SERVICE LETTER

No. 523

Subject: Modification to the Fuselage Bulkhead

Models Affected: PA-31 and PA-31-300 Navajo

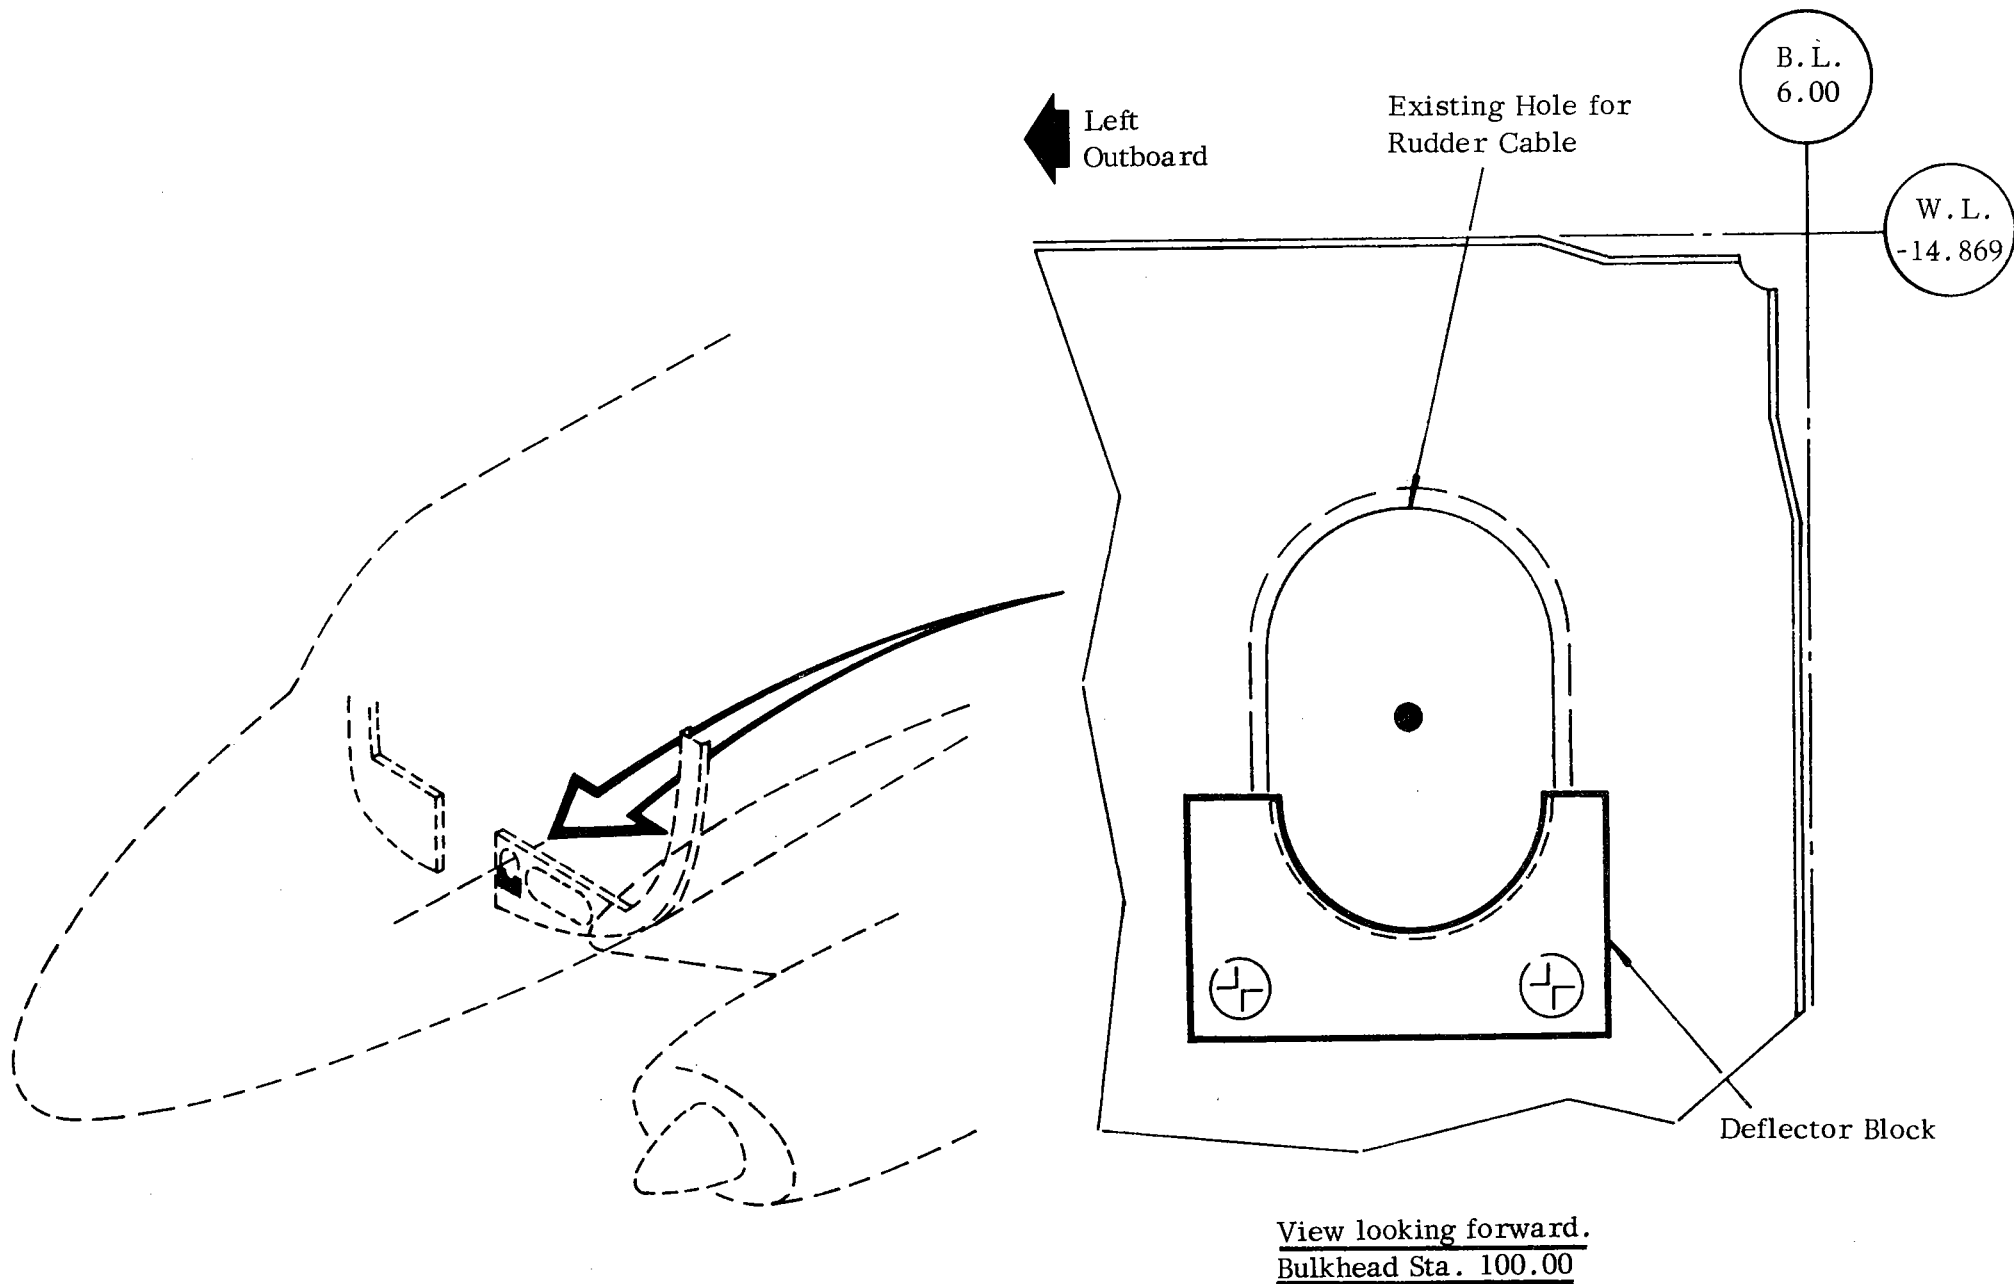
Purpose: To provide materials and instructions necessary to install a phenolic guard block at fuselage bulkhead station 100.

Installation of the phenolic guard block device contained in Kit No. 760 295 will preclude the possibility of the rudder cable chafing the bulkhead cutout at fuselage bulkhead station 100. (See sketch on reverse side of this letter for more descriptive information.)

Instructions: Contained in Kit No. 760 295; Fuselage Bulkhead Modification

Material Required: Kit No. 760 295; Fuselage Bulkhead Modification
